SHOP FLOOR & BACK OF HOUSE @ Custom

Proposal Number:	Fixture Revision: Merchandising:
P1	F16
✉	Andrew.Wignall@coop.co.uk

Drawing Status Stage 5: Locked

Peterborough, Hampton Gardens

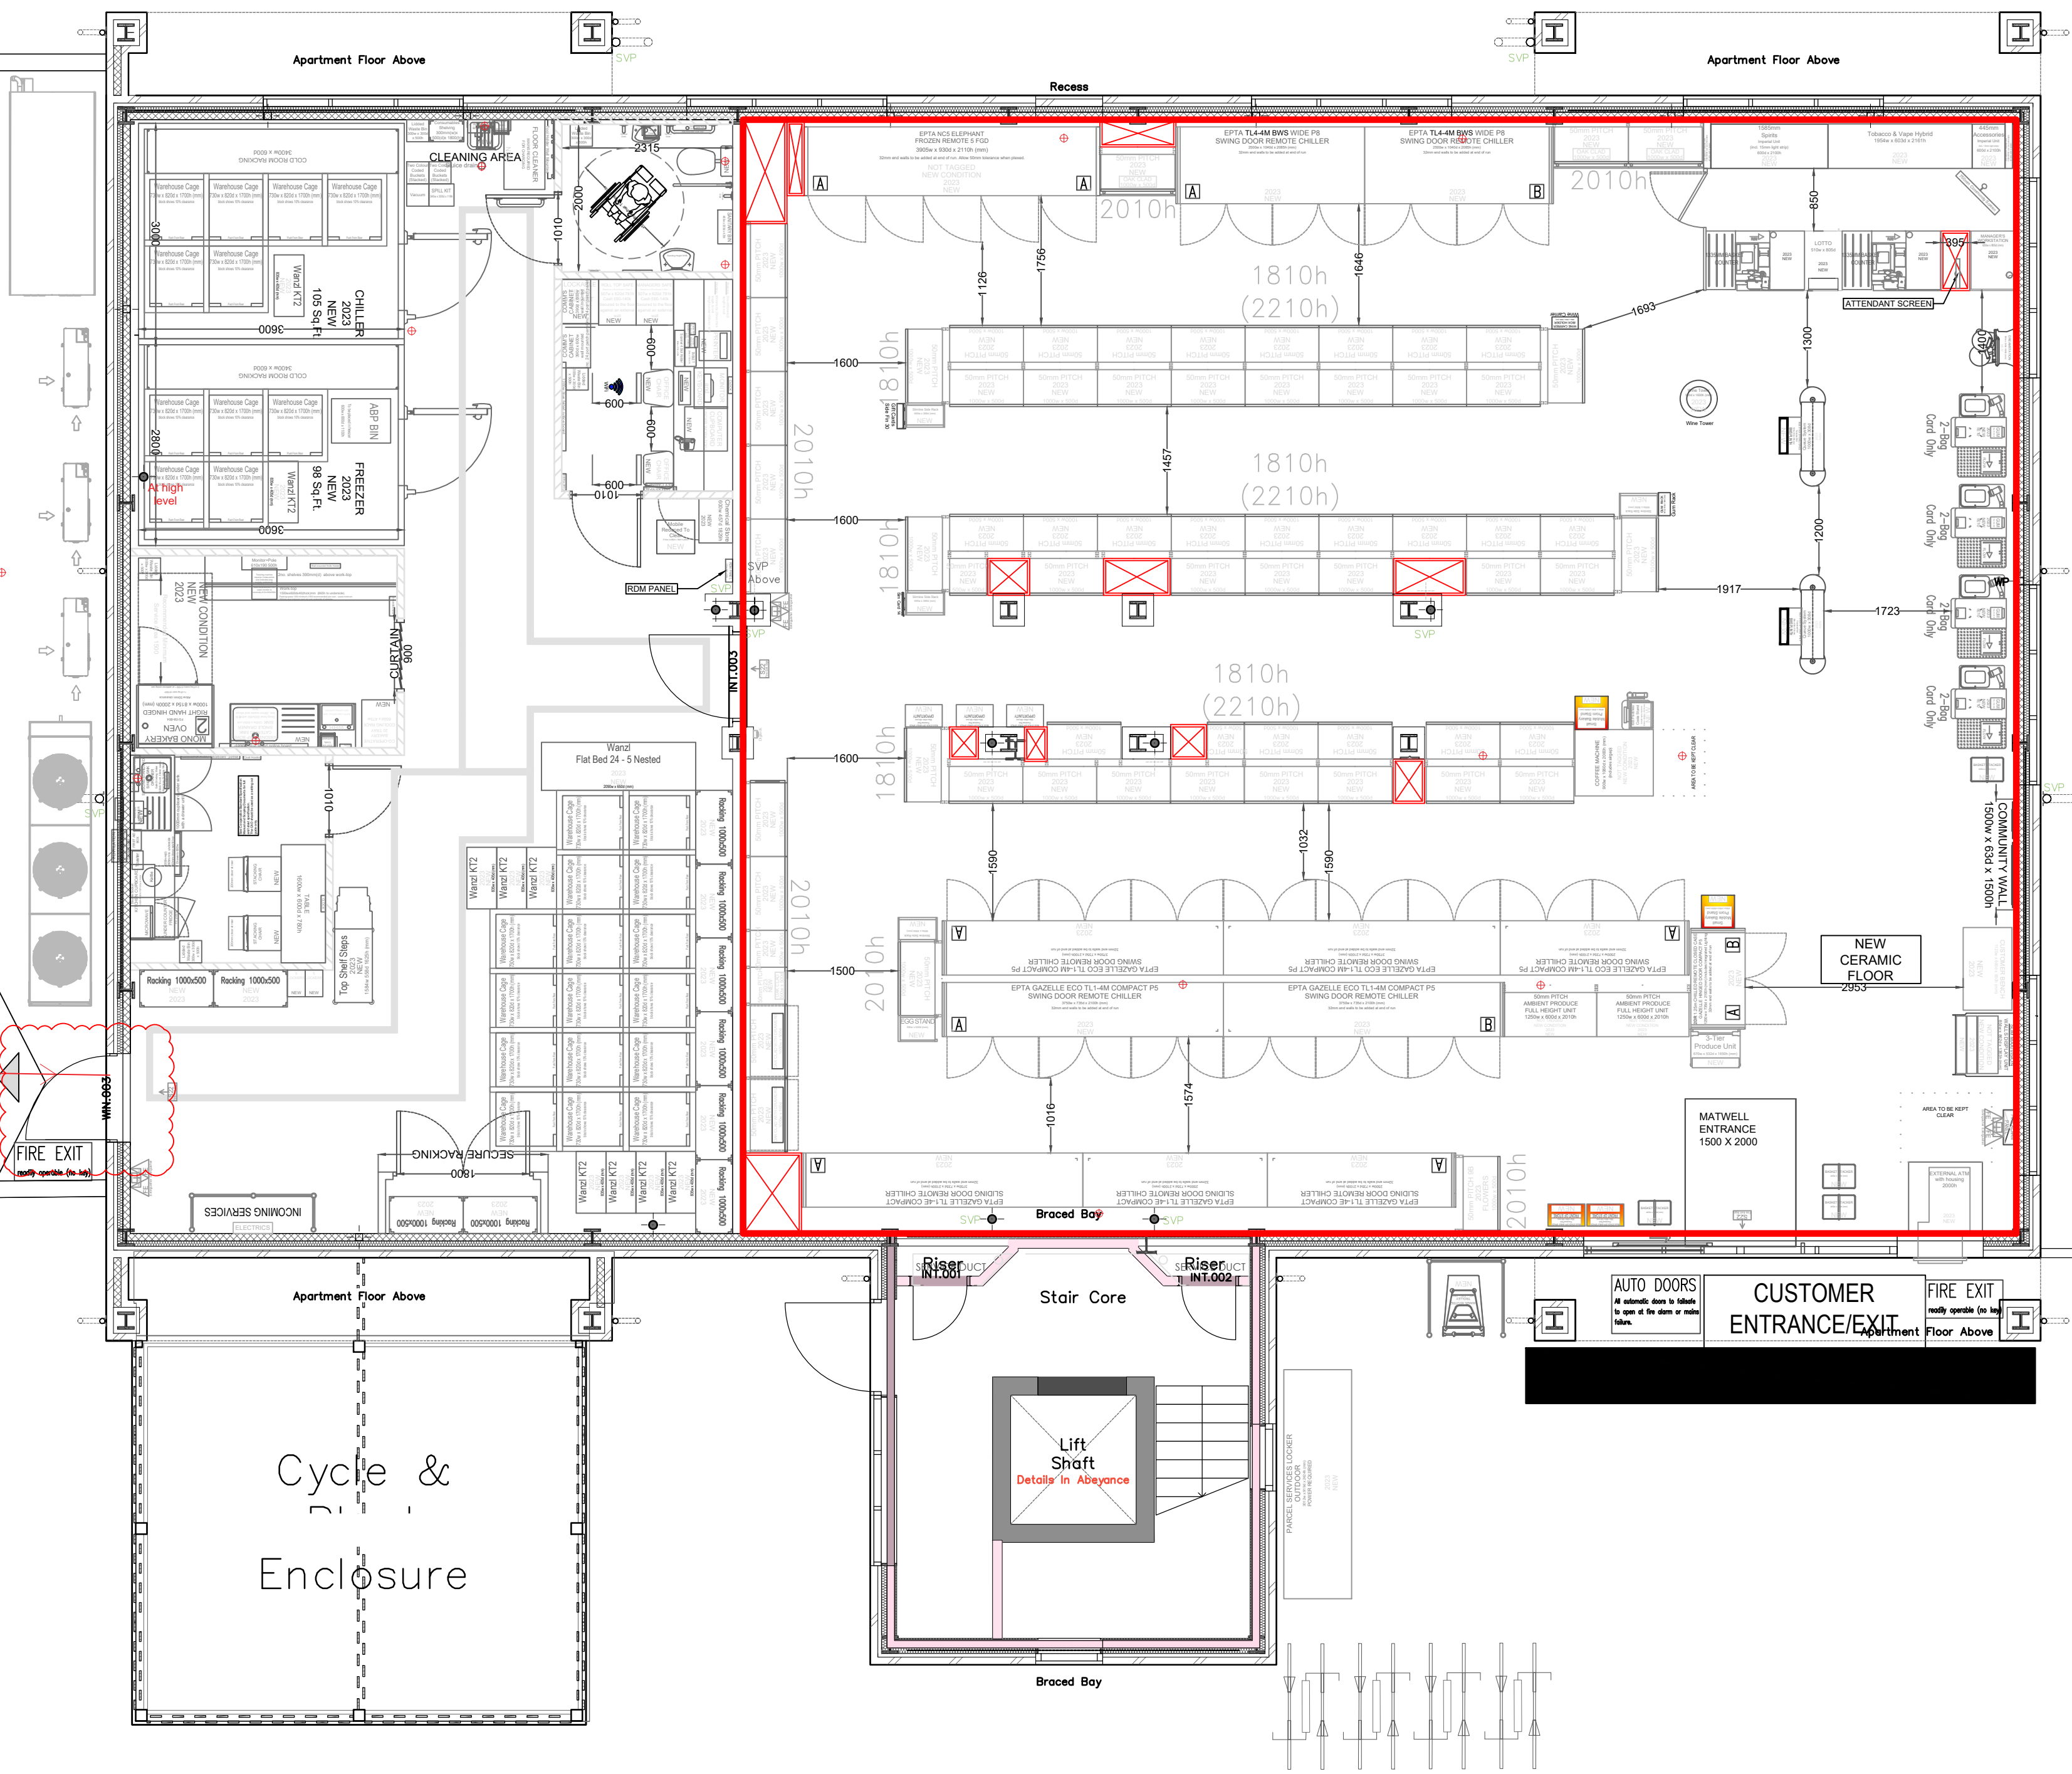
- Description of Amends**
29.09.22 / P1F7M0 / APW
1. Shell overlay with changes to columns.
 2. Doors added to cases where appropriate.
 3. Bays changed around columns.

4. Reduce amb produce by 1 bay
 5. Increase chilled produce to 4 bays
 6. Reduce combined chilled by 2 bays, reducing the chilled island to incorporate newly instructed column.

7. Add 1 x Cash and Card AST
 8. Reduce bakery by 0.5 bays.
 9. Back of house redesigned as location of freezer slab has changed and the location of the incoming electrics panel. Cage count remains the same.

- 07.10.22 / P1F9M0 / APW
1. BOH increased for cage storage.
 2. Relocate warehouse door.
 3. Redesign BOH so cages are located nearer the goods in door.
 4. Relocate amb beer to the gondola

5. Produce to all sit in chilled island.
 6. Relocate meat.
 7. Extend gondolas to reduce large space at front of store.
- 06.12.22 / P1F9M0 / NS
- Warehouse wall reverted to F7.

- 12.10.23 / P1F10M0 / APW
1. S2S updated.
 2. Flowers increased to 1 bay.
 3. Frozen decreased to 4 doors.
 4. Add another bay in next to frozen, move amb down on perimeter to accommodate, extending box out as there is a 5mm overlap.

5. AST to be 4 card only, removing 2 x card and cash, replacing with 2 card only.
 6. Amazon locker replaced for 2m generic block.
- 19.10.2023 / P1F11 / JD

1. 5 door frozen added
 2. Doors added to perimeter chilled and island first aisle changed to slide
 3. FTG chiller added to island to reduce void space at the front of store

4. Ambient produce also moved into island. 1m ambient end as been added in its previous location
- 17.11.2023 / P1F12 / JD
1. Locker changed to 4m block

2. Chilled perimeter changed to slide and island side changed to swing
 3. SR added to end ambient
 4. Door block added
 5. Trolley bay added
 6. Coffee centralized

- 23.11.2023 / P1F13 / JD
1. Locker moved to bike rack location and bike moved to opposite side of lift area
- 06.12.2023 / P1F14 / JD
1. Trolley bay rotated to face out

2. Locker reduced to 3m block and moved slightly further towards the store
 3. Cycle racks relocated to original side
- 07.12.2023 / P1F15 / APW
1. Offshelf added

2. Freezer doors direction changed to reflect the B/P.
- 08.02.2024 / P1F16 / SN
1. Fire exit door in warehouse changed to single leaf
